MDOT – STATE HIGHWAY ADMINISTRATION
Office of Traffic & Safety
TRAFFIC ENGINEERING DESIGN DIVISION

US 40 @ CENTENNIAL LANE /BETHANY LANE

DATE: SEPTEMBER 22, 1972 F.A.P. NO.
SCALE: 1"=20' S.H.A. NO. HO–477X–785
TS/FILE NO. 717 K
SHEET NO. ___ OF ___

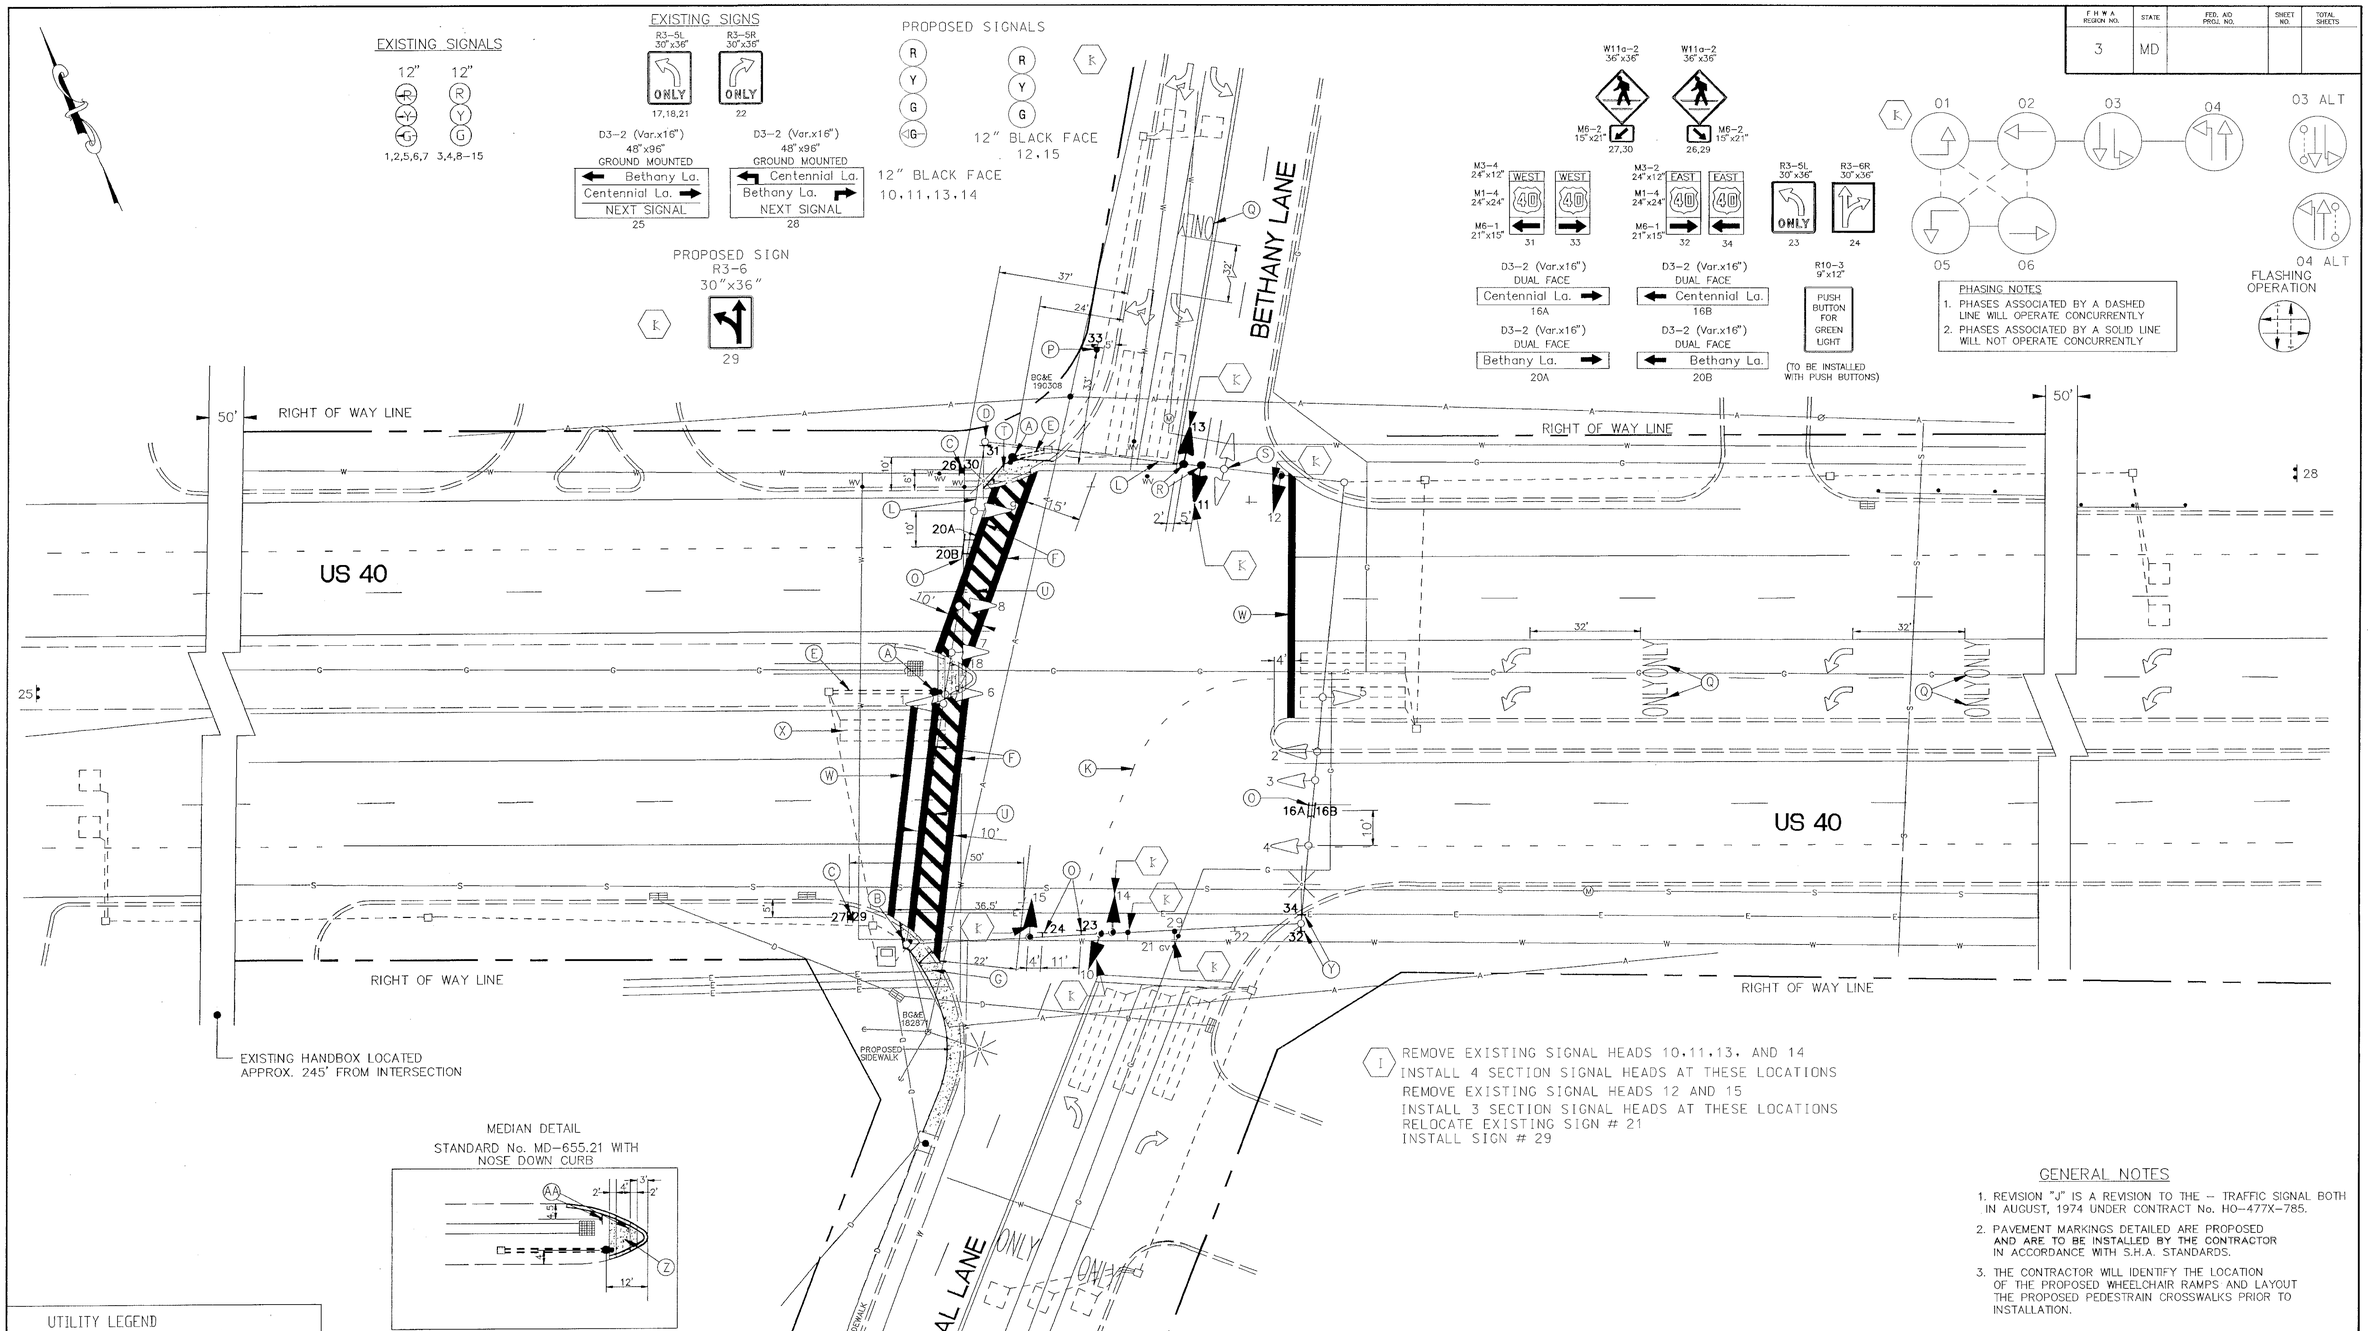
REMOVE EXISTING SIGNAL HEADS 10.11.13. AND 14
INSTALL 4 SECTION SIGNAL HEADS AT THESE LOCATIONS
REMOVE EXISTING SIGNAL HEADS 12 AND 15
INSTALL 3 SECTION SIGNAL HEADS AT THESE LOCATIONS
RELOCATE EXISTING SIGN # 21
INSTALL SIGN # 29
